- 1) The device is set to operate at a defined level. During test, continuous transmit is forced by means of applicant supplied software. All tests are done using this software, so including power measurements, power drift measurements and the measurements of spot SAR drift during SAR evaluation. Should the device not transmit at max power, one or more of the drift or power measurements would have revealed that.

Figure 1: 5 GHz contour plot entire device

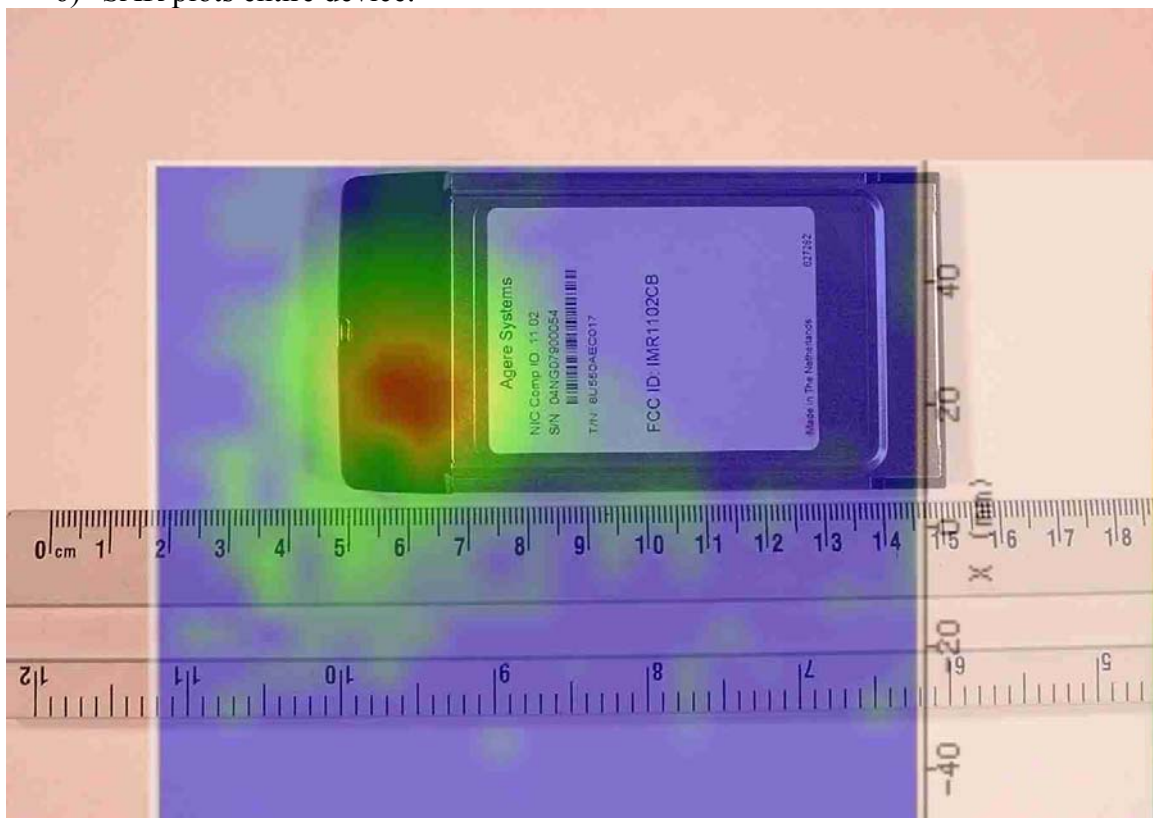
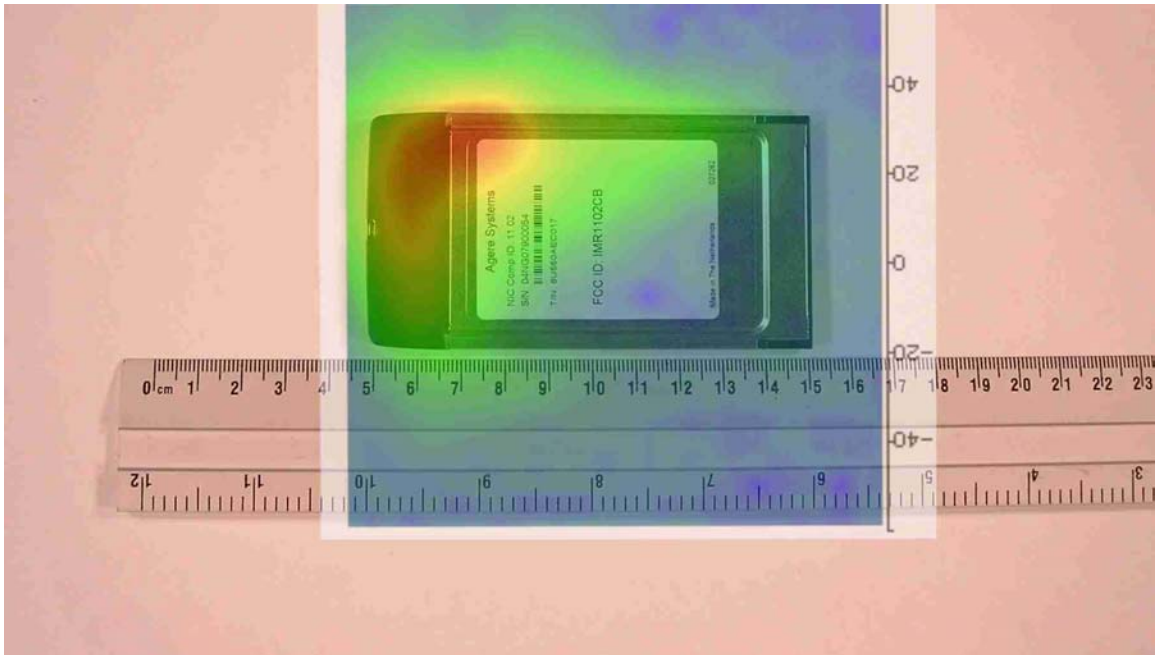
- 6) SAR plots entire device:

Figure 3 channel 149 lapheld

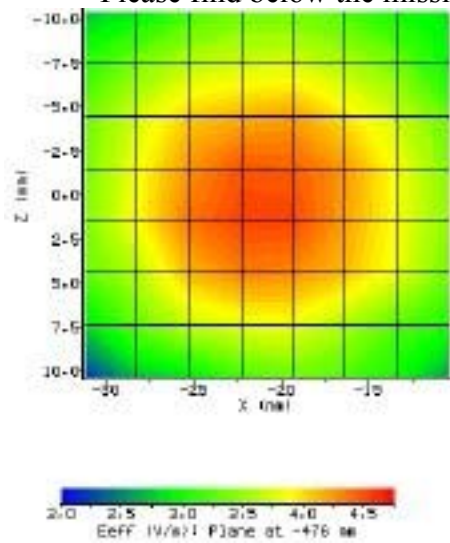
7) Contour plots:
Please find below the missing plots
